SENZ have reviewed this drawing for its compliance with the structural design intent & building code (B1), as referenced in the structural producer statement (PS1). Please refer to the PS1 for the extent of works by SENZ. We take no responsibility or accept liability for items outside the scope of our signed PS1. Job: 059-001

2000 L Tank - Fixed to a Timber Fence

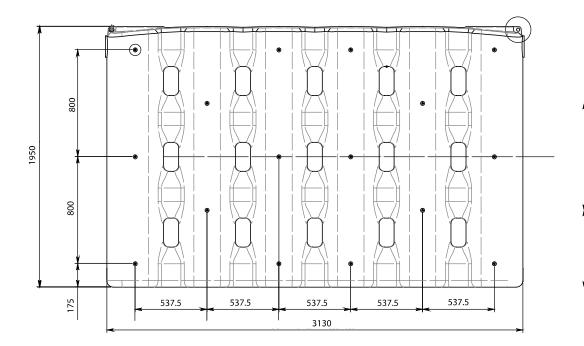
Unless Noted - All other details as per fixing the 1000 L tank (above)
